**PARK CITY BOARD OF ADJUSTMENT MEETING  
SUMMIT COUNTY, UTAH  
August 19, 2025**

7.A. **560 Deer Valley Drive – Variance** – The Applicant Requests a Variance from the Regulations For Parking Areas For Historic Residential Sites Outlined in Land Management Code § 15-13-2(B)(1)(G) to Construct a Parking Area in Front of the Significant Historic Site. PL-25-06626 (20 mins.)  
(A) Action

**Subject:** 560 Deer Valley Drive  
**Application:** PL-25-06626  
**Author:** Meredith Covey, Planner I  
**Date:** August 19, 2025  
**Type of Item:** Variance

Image 3: Proposed site plan submitted by Applicant, Staff has shaded the Historic Structure in green, the disturbed area in blue, the paved Parking Area in orange and the area that encroaches into City Right of Way in pink.

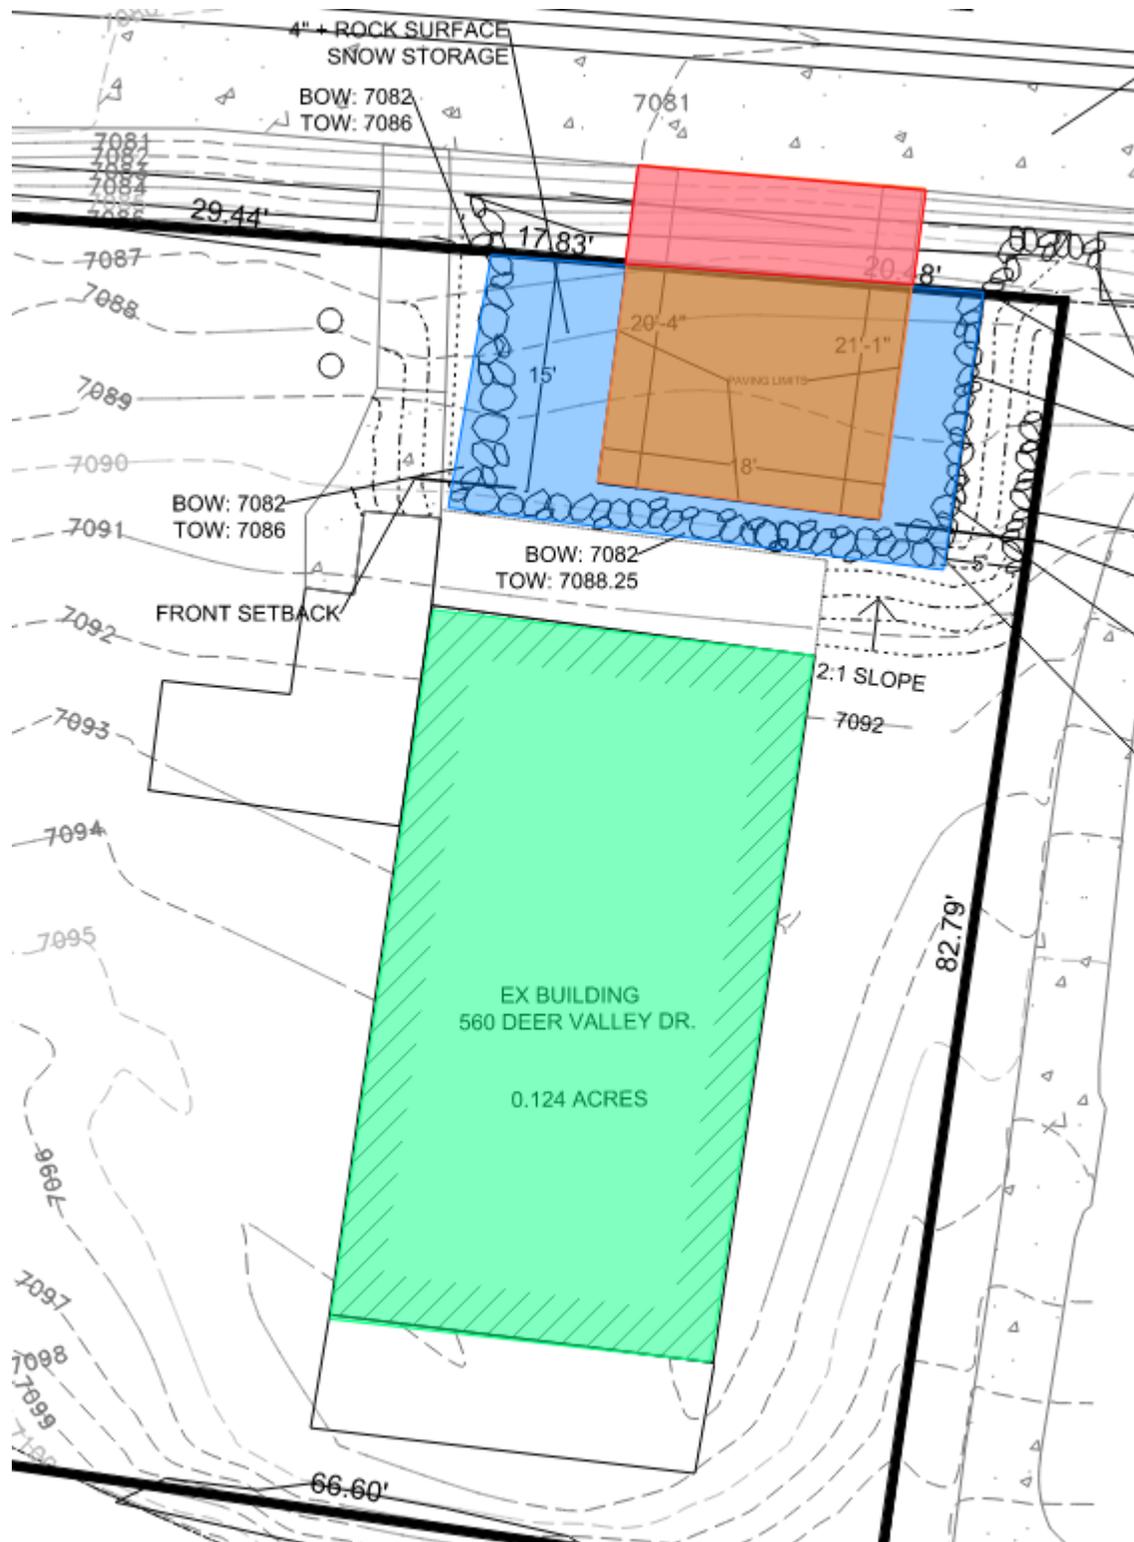
Planning staff reviewed the proposal and requested that the Applicant consider shifting the Parking Area to a side yard to comply with LMC [§ 15-13-2\(B\)\(1\)\(g\)](#). Additionally, Planning staff requested that the Parking Area be shifted to be entirely on the Applicant's property to eliminate the request to use City Right-of-Way for the private Parking Area. Planning staff notified the Applicant that an Encroachment Agreement would be required for the utilization of City Right-of-Way and that should the

- The visual impacts of the proposed Parking Area are not minimized.
- There is no landscaped separation between the proposed Parking Area and walkway.
- The proposed Parking Area impacts 505 square feet of Steep Slopes, substantially disturbing the existing topography of the site and integral site features, requiring significant retaining walls.
- The Parking Area is not located within the rear yard beyond the rear wall plane of the Significant Historic Structure.
- The Parking Area is not visually buffered from adjacent properties and Deer Valley Drive.

Figure 2: Proposed alignment of the Thaynes net from the Applicant's proposed Plans (Attachment 1).

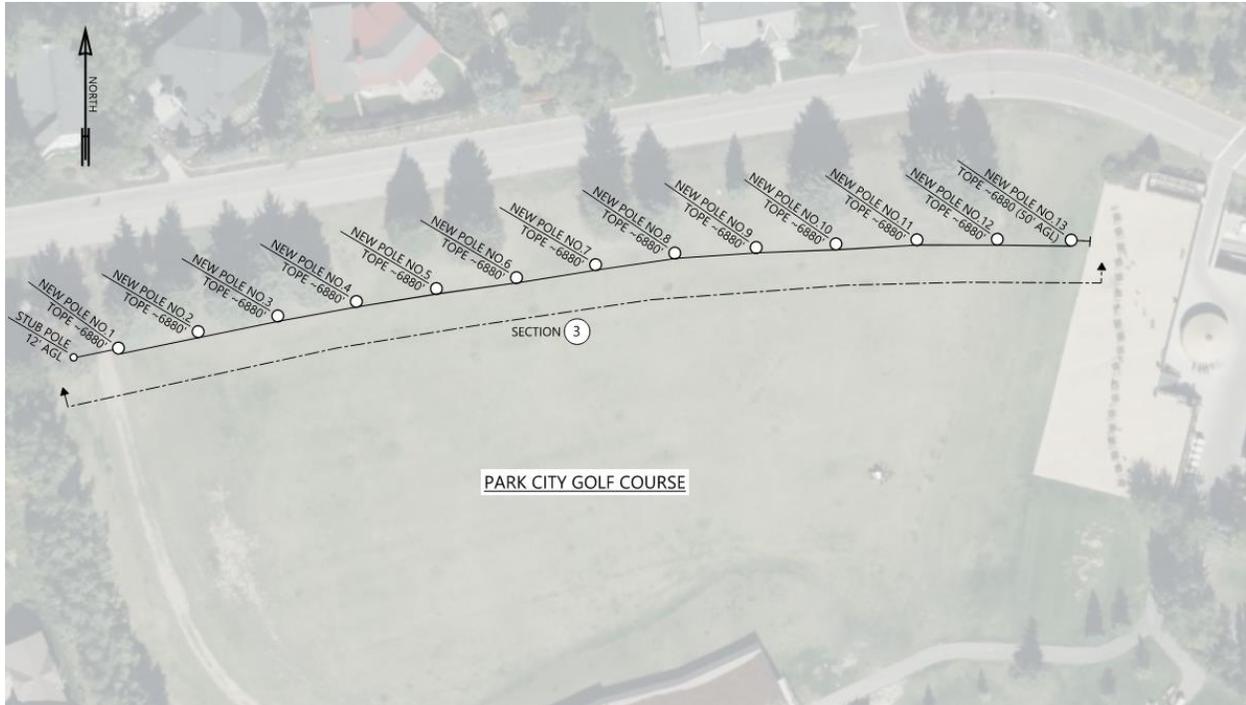
The net proposed along Thaynes Canyon Drive is 600 feet long, and ranges in height from 20 to 50 feet from Final Grade, to provide protection for users of the new multi-use pathway installed along Thaynes Canyon Drive.

Figure 5: Proposed golf ball net relative to the Three Kings Water Treatment Plant. See Applicant's proposed plans (Attachment 1).

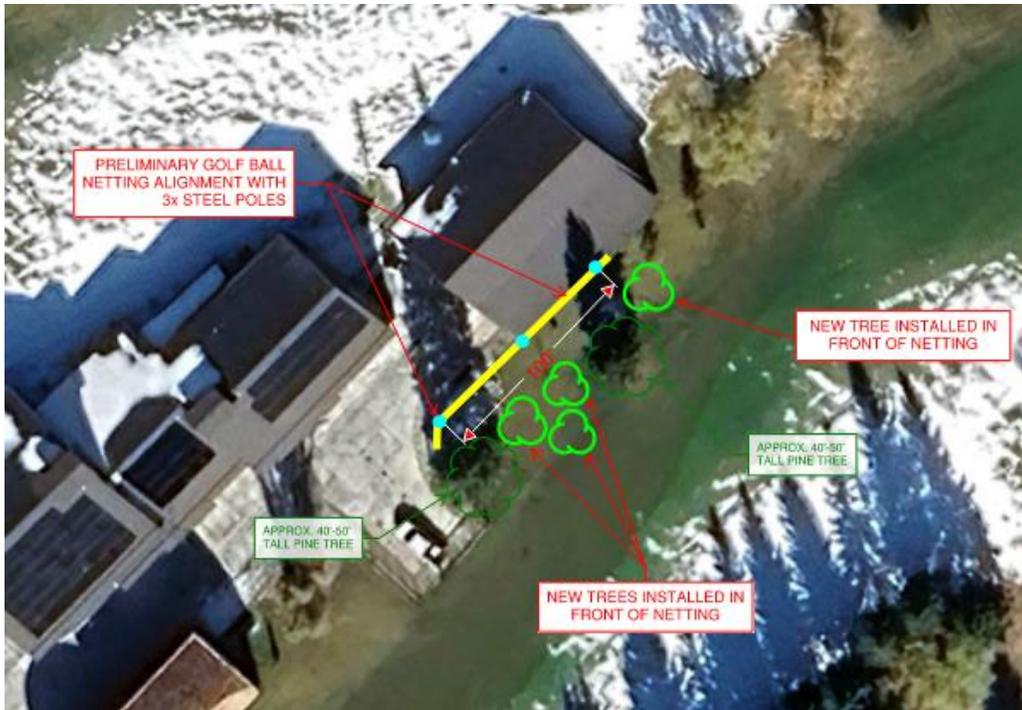
The net proposed for the Three Kings Water Treatment Plant is 100 feet long and a maximum of 50 feet tall and is located northeast of the Three Kings Water Treatment Plant to provide protection for the facility.

Figure 5: Existing and proposed elevations showing the equipment to be removed and replaced (outlined by staff in red). Taken from Applicant's Proposed Plans (Attachment 1).

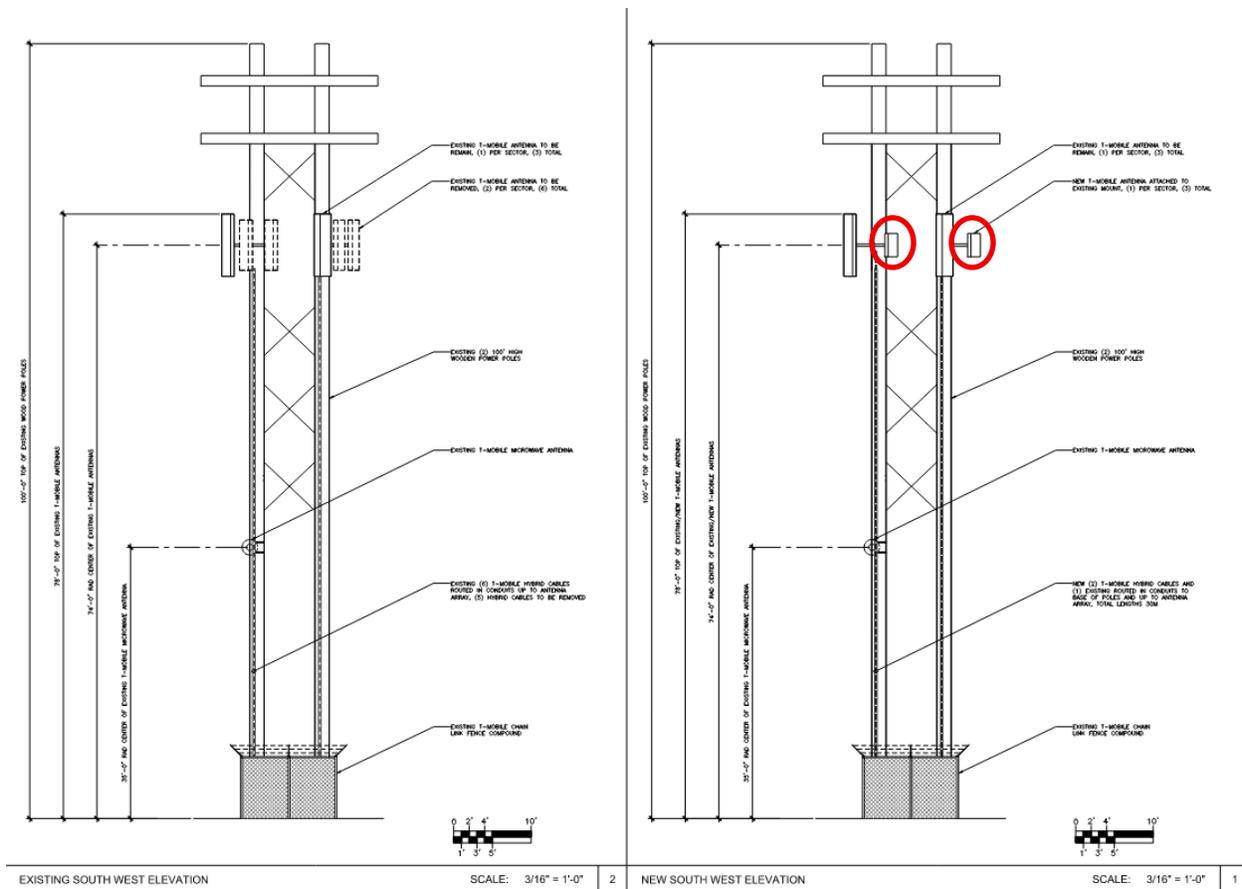
While reducing the overall size of the existing Telecommunications Facility, the Applicant requests a Variance to allow upgrades to a Telecommunications Facility that exceeds the ROS Zone Height and size limitations for panel antennas.
